**SUPPLEMENTAL PACKAGE  
FOR 7/7/21 CITY COUNCIL MEETING**

CITY OF GENEVA LOCHLAND ROAD PROJECT

Proposed Planned Unit Development

1115 Lochland Road (NYS-14 [American Legion Property])

**DRAWING TITLE:**  
**SKETCH PLAN**

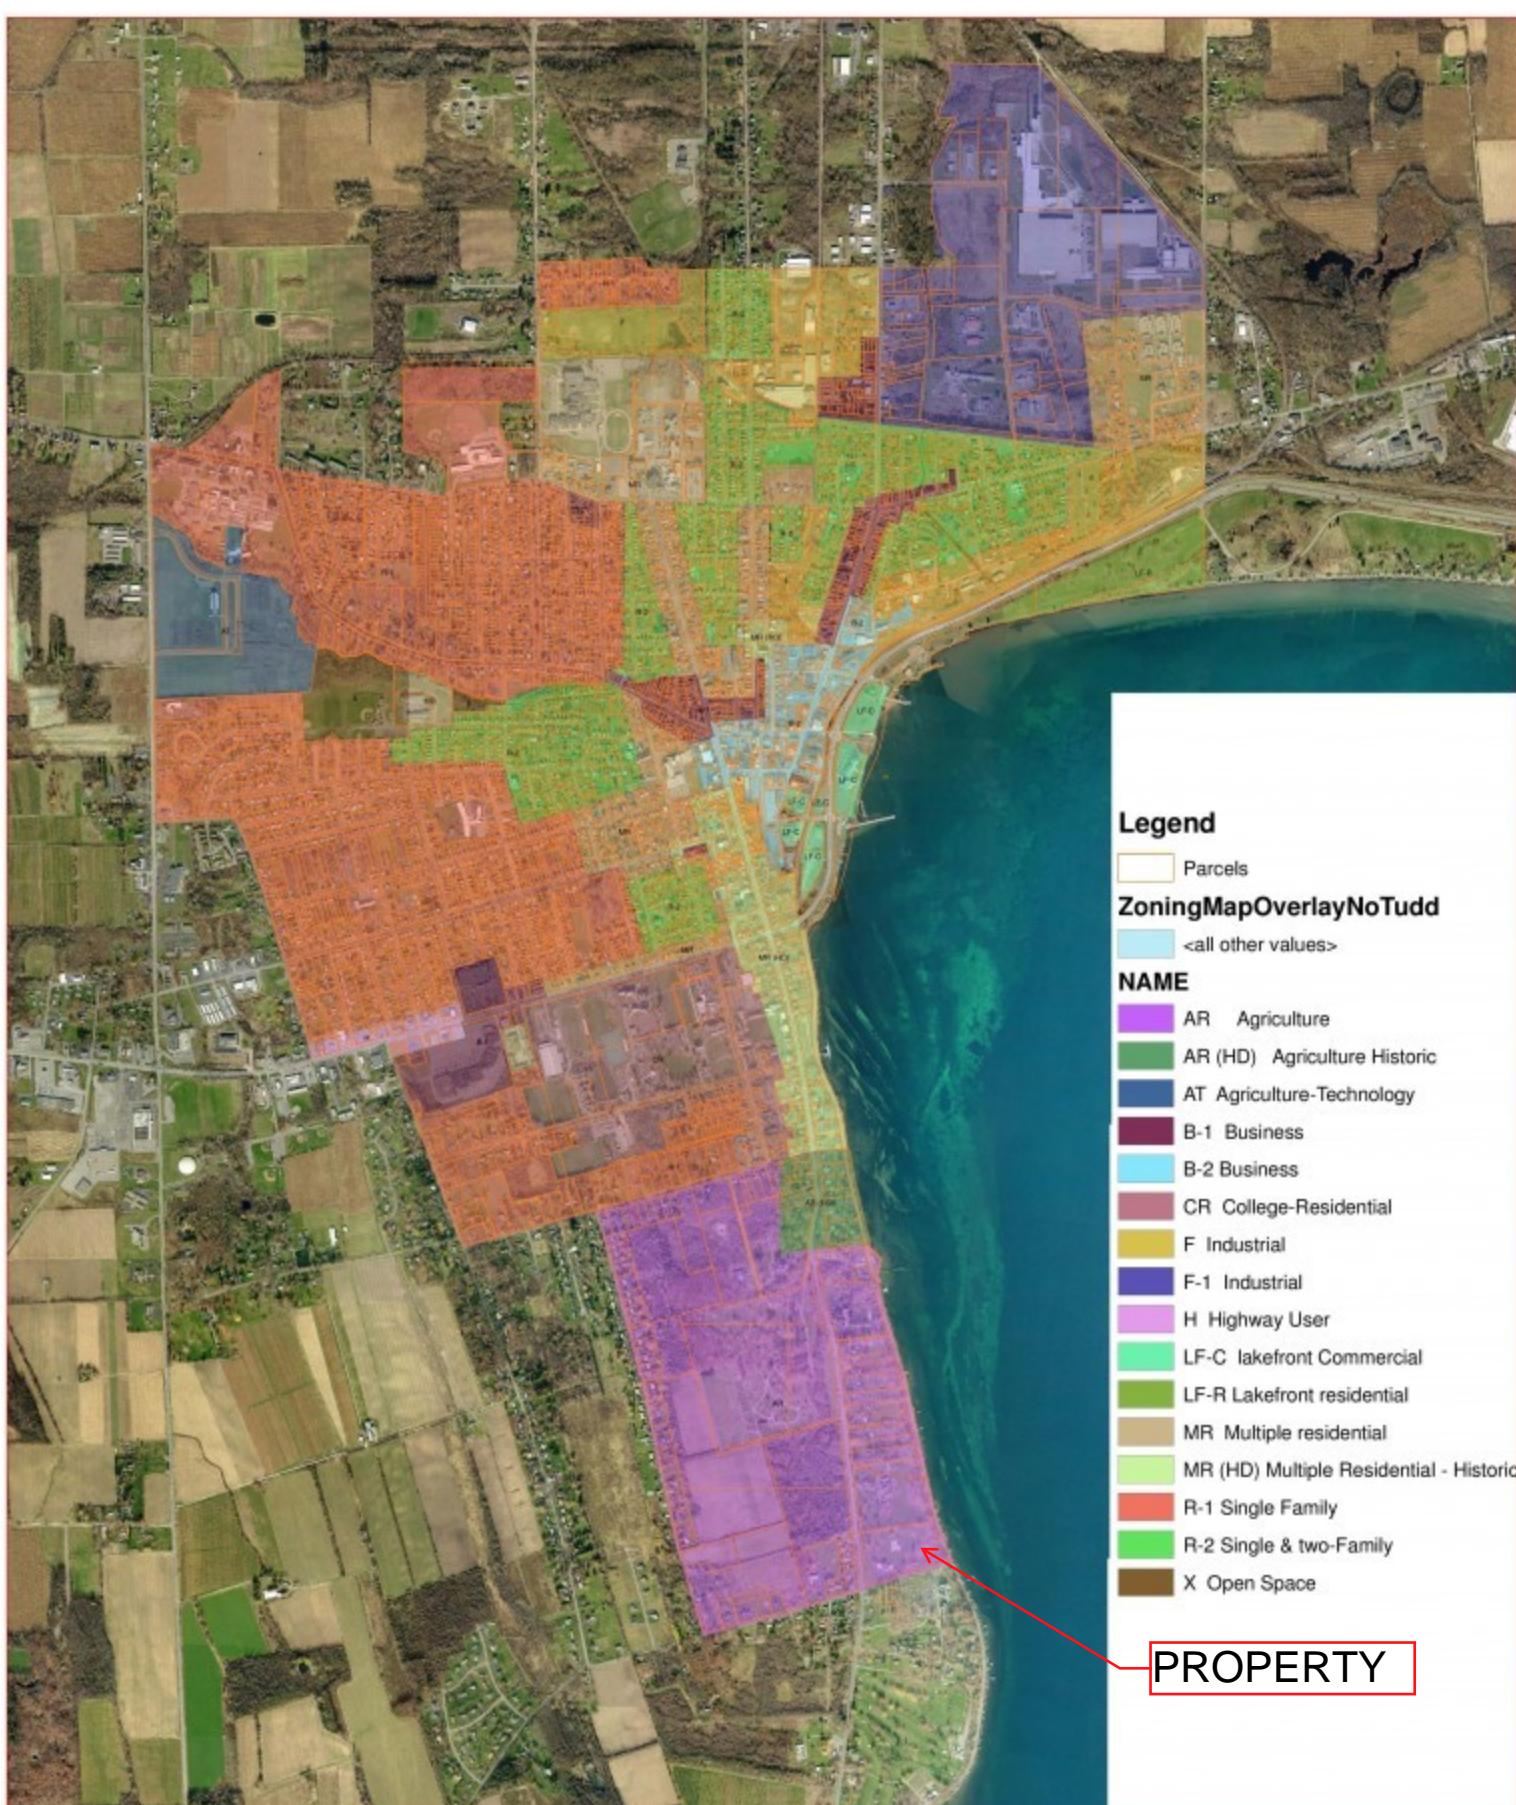
1. Does City Council need to re-zone the property to LD District, before the planning board and city council can review suitability of rezoning in accordance with a LD PUD plan and accompanying materials? Does the planning board need to review the concept plan before submission of a more detailed LD PUD rezoning application?

3. The applicant must document that 20% of the lot area (2.6 acres) is designated for developed and unimproved common or public open space and recreation uses at the time of initial planning board LD PUD concept review.

4. The LD PUD regulations indicate no more than 65 percent of total residential units may be any single type.
5. The concept plan does not appear to provide a visual screen between residential and non-residential uses.

6. Section 350-10 C Indicates the concept plan review is required to include review of phasing and identification of easements, project demand, water and sewer connection points and storm drainage system.

7. The submitted materials do not provide information on changes in the view shed.
8. There is an ADA route labeled from the upper terrace to the lower terrace. What other portions of the pedestrian circulation system are ADA accessible? If the route from public parking to the American Legion Memorial is not accessible, how will visitors access the area?

11. It appears that most of the townhouse driveways are 20' in length and accommodate 1 vehicle. There appear to be at most 28 additional parking spaces in the residential section of the site. While this meets the requirements of the PUD regulations for off-street parking for attached single family homes, it does not provide additional parking (one space per 200 SF net floor area) for the community center. Will street parking be allowed? The parking standards do not provide visitor parking.

1. Consider possible management solutions for stormwater on impervious surfaces which run up and down slope such as the center sidewalk and driveways.
2. Plans do not show which areas will be served by which stormwater facilities.
3. Opportunity exists to utilize sustainable shoreline practices to create a buffer between lake and proposed development. Consider appropriate vegetation within rear setback. The Ontario County Soil and Water Conservation District is a resource for this type of project.
4. Impervious surface proposed is significantly more than the existing use. Consider incorporating more green infrastructure practices where possible.

7. How will project contribute to improved pedestrian and bicycle character and safety along SR 14?
8. The ADA pathway shown on the concept plan is likely not feasible given site slope.

**RESPONSE:** Acknowledged.

**RESPONSE:** All NYSDEC requirements and regulations will be complied with through green infrastructure practices. Additional detail will be provided with the final site plan application.
